TOWN OF NEWBURGH
PLANNING BOARD
TECHNICAL REVIEW COMMENTS

PROJECT: HUDSON VALLEY PERSONNEL SUPPORT CENTER OF
JEHOVAH'S WITNESSES
PROJECT NO.: 2014-17
PROJECT LOCATION: SECTION 97, BLOCK 2, LOT 31.1, 30.22 & 33
PROJECT REPRESENTATIVE: MASER ENGINEERING
REVIEW DATE: 10 APRIL 2015
MEETING DATE: 16 APRIL 2015

Re: Hudson Valley Personnel Support Center of Jehovah's Witnesses
Tax Lot 97-2-30.1, 30.22, 33
Town of Newburgh, Orange County, New York
MC Project No. 13000398C

SANITARY PUMP STATION SITE PLAN
SCALE: 1"=10'-0"

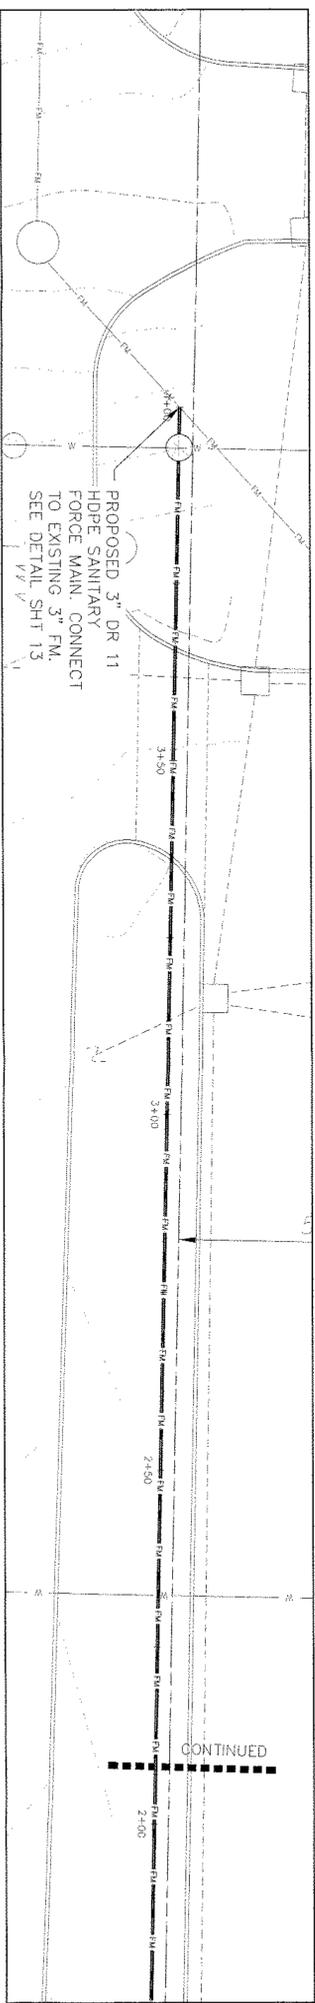
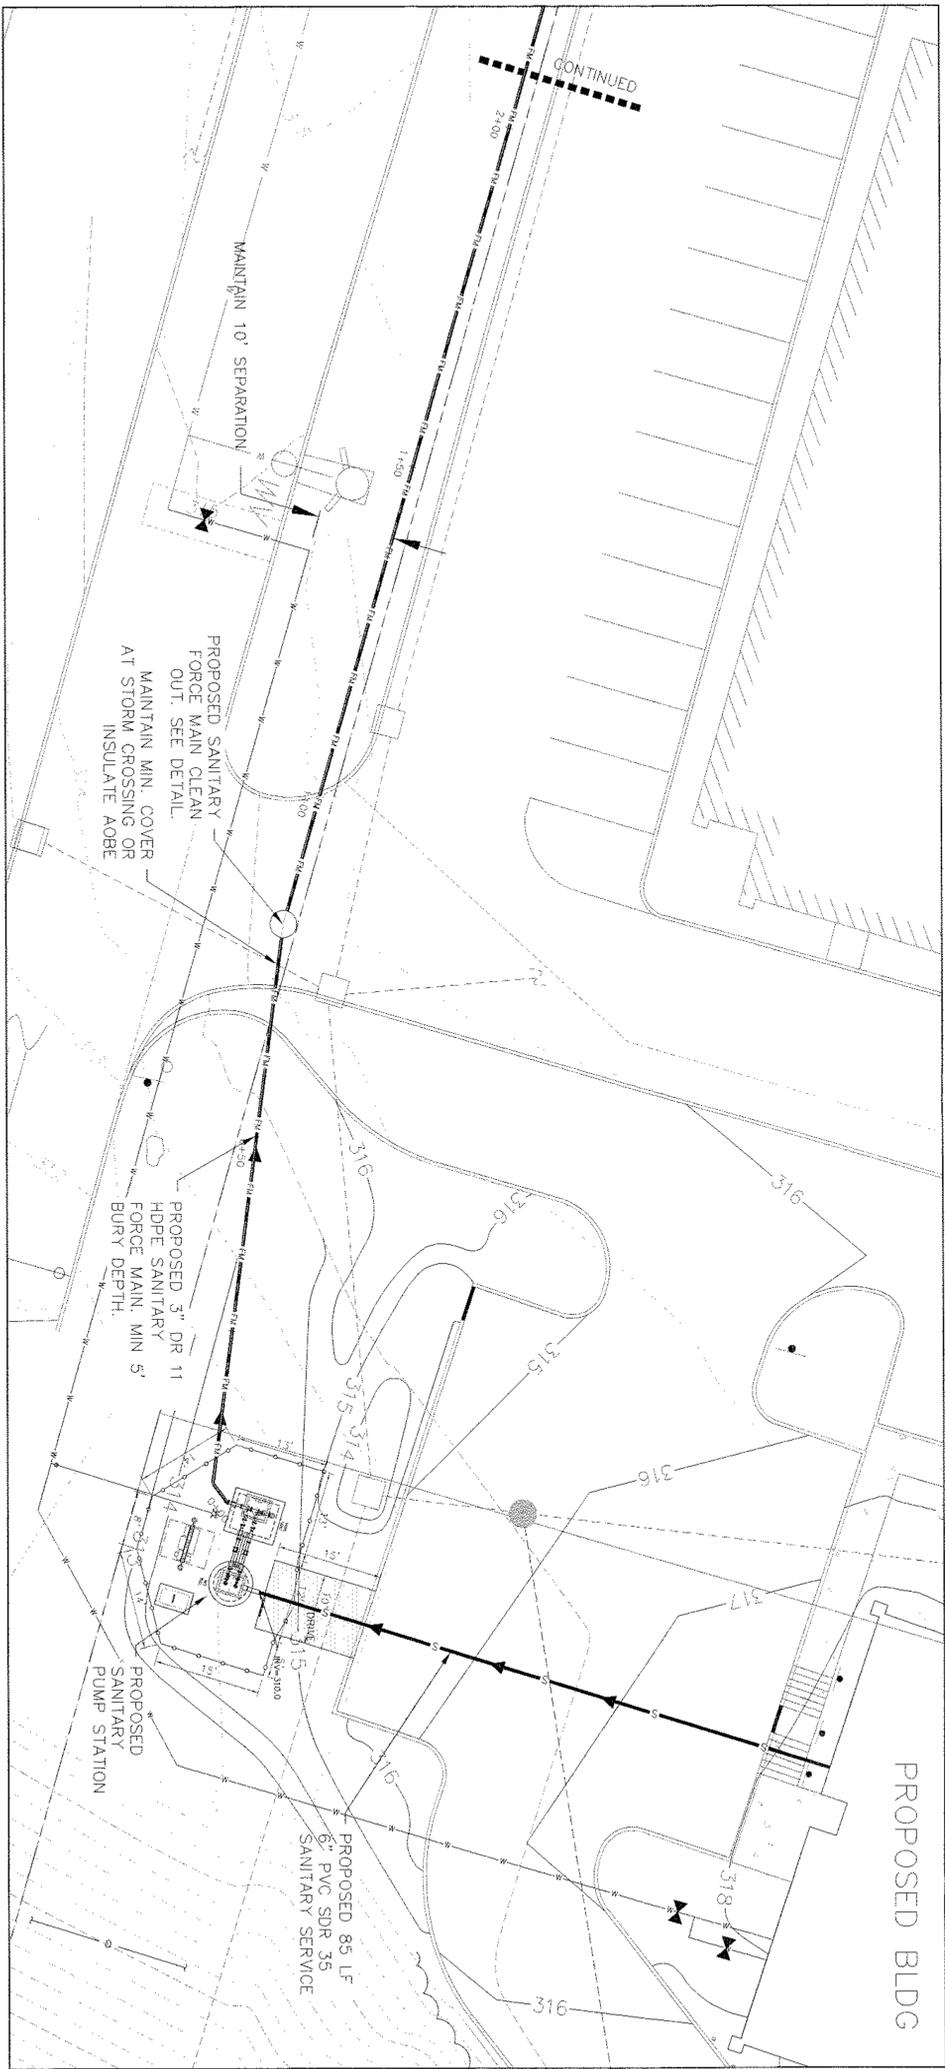
Comment 13: Detail for sanitary sewer forcemain interconnect should be provided.

Response 13: A detail for the forcemain interconnect has been provided as part of the sanitary sewer pump station details, see Sheet #13.
